SUBJECT: SURRY UNITS 1 AND 2 - ISSUANCE OF AMENDMENTS RE: HEATUP AND COOLDOWN CURVES (TAC NOS. 67386, 67387, 71555 AND 71556)

These amendments revise the heatup and cooldown curves to be effective from 11 effective full power years (EFPY) of operation to 15 EFPY.

SAFETY EVALUATION BY THE OFFICE OF NUCLEAR REACTOR REGULATION  
RELATED TO AMENDMENT NO. 147 TO FACILITY OPERATING LICENSE NO. DPR-32  
AND AMENDMENT NO. 143 TO FACILITY OPERATING LICENSE NO. DPR-37  
VIRGINIA ELECTRIC AND POWER COMPANY  
SURRY POWER STATION, UNIT NOS. 1 AND 2  
DOCKET NOS. 50-280 AND 50-281

Figure 3.1-1 RCS Heatup Limitations

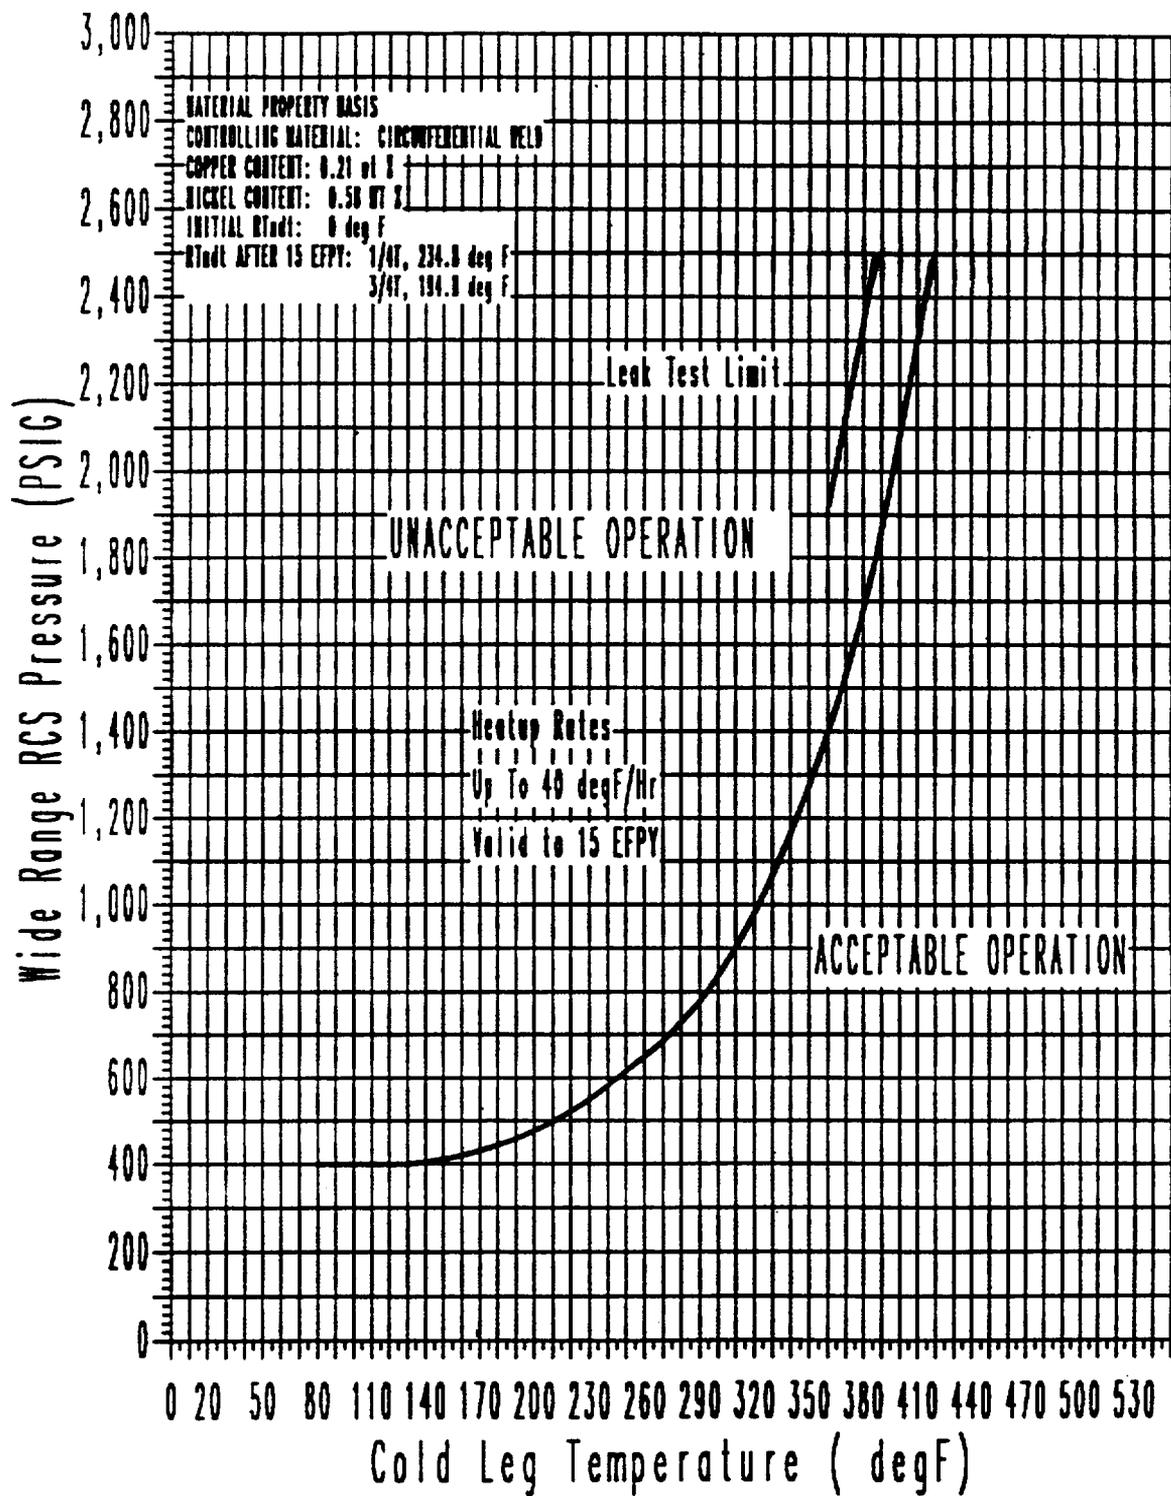
Figure 3.1-1 may be used for heatup rates of up to 40°F/hr.

The heatup limit curve, Figure 3.1-1, is a composite curve which was prepared by determining the most conservative case, with either the inside or outside wall controlling, for any heatup rate up to 40°F per hour. The cooldown limit curves of Figure 3.1-2 are composite curves which were prepared based upon the same type analysis with the exception that the controlling location is always the inside wall where the cooldown thermal gradients tend to produce tensile stresses while producing compressive stresses at the outside wall. The heatup and cooldown curves were prepared based upon the most limiting value of the predicted adjusted reference temperature at the end of 15 EFPY. The adjusted reference temperature was calculated using results from a capsule removed after the eighth cycle. The results are documented in WCAP 11415 and WCAP 11492-1 for Unit 1 and WCAP 11499 and WCAP 11505 for Unit 2.

The proposed Technical Specifications revisions affect the P/T limits shown in Figure 3.1-1. This curve is being split into two curves, Figures 3.1-1 and 3.1-2, representing P/T limits for heatup and cooldown, respectively. In addition, the maximum heatup rate is limited to 40°F per hour. The proposed P/T limits on the reactor coolant system for heatup, cooldown, leak test, and criticality are valid through 15 EFPY, because the limits conform to the requirements of 10 CFR Part 50, Appendices G and H. VEPCO has also satisfied Generic Letter 88-11, because the method in Regulatory Guide (RG) 1.99, Rev. 2 was used to calculate Adjusted Reference Temperature (ART). Hence, the proposed P/T limits will be incorporated into the Surry Power Station Units 1 and 2 Technical Specifications. The LTOP system setpoint is changed based on the revised P/T limits.

In the modified Appendix G heatup limit curve, the cold leg temperature corresponding to the pressurizer safety valve setpoint of 2485 psig is 420°F. This point is used to bound all of the low temperature transient analyses. Below 420°F, the anticipated low temperature overpressurization transients

Figure 3.1-3 Fast Neutron Fluence ( $E > 1$  MeV) as a Function of Full Power Service Life (EFPY) for Surry Unit 1

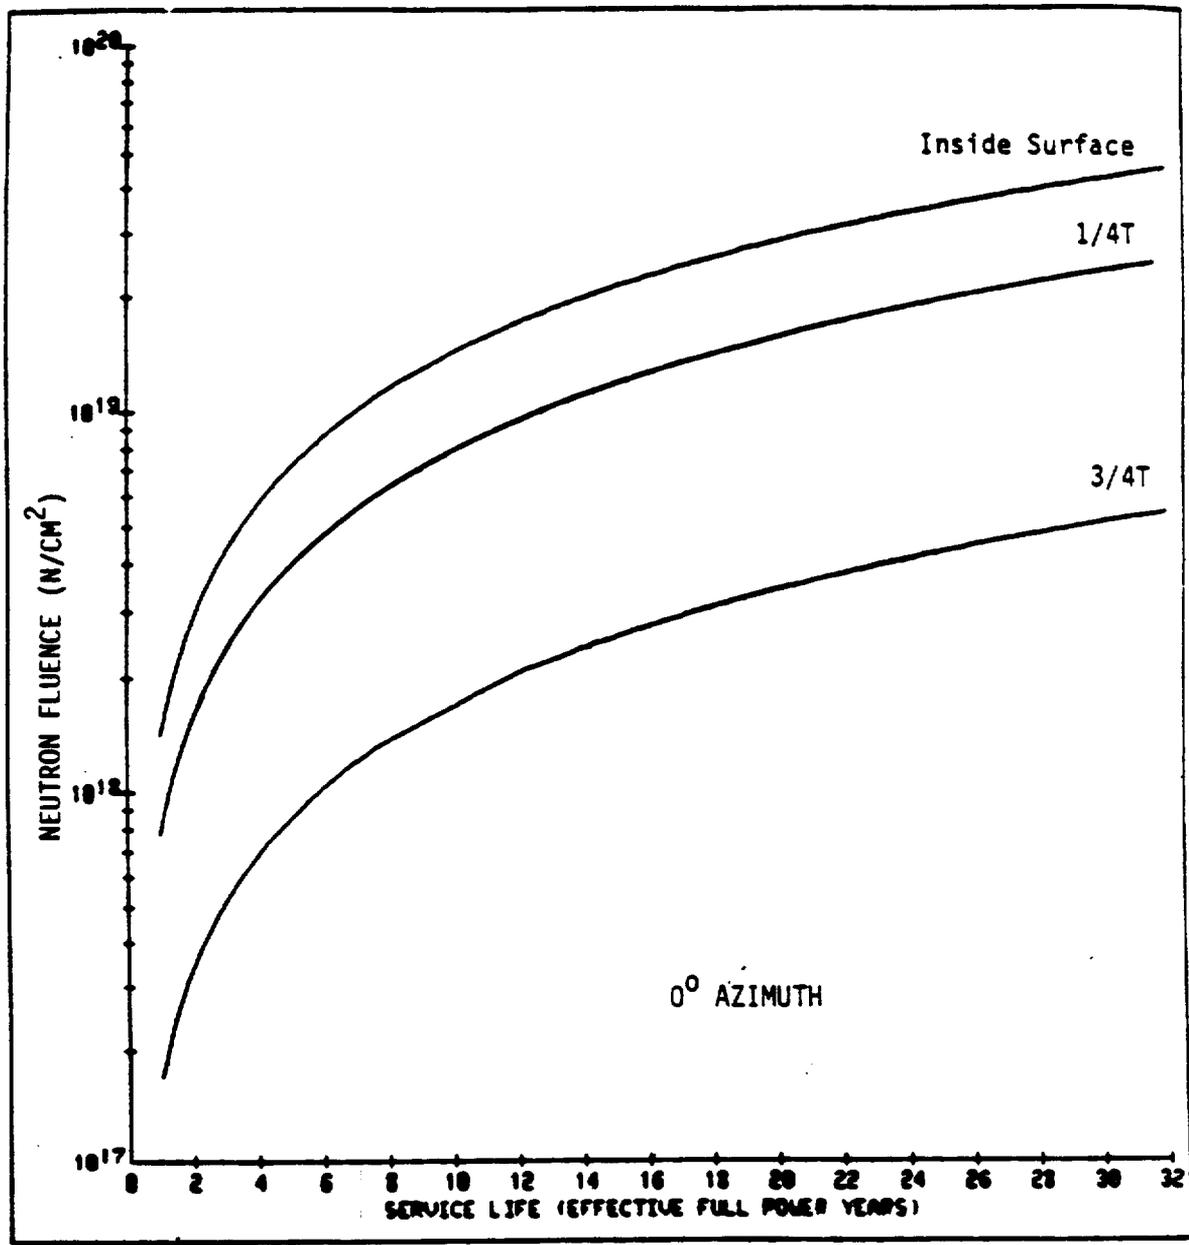
TS 3.1-6  
TS 3.1-7  
TS 3.1-8  
TS 3.1-9  
TS 3.1-10  
TS 3.1-11  
TS 3.1-12  
TS 3.1-23  
TS 3.1-25  
Figure 3.1-1  
Figure 3.1-2  
Figure 3.1-3  
Figure 3.1-4  
Table 3.1-1  
Table 3.1-2  
TS 4.2-4
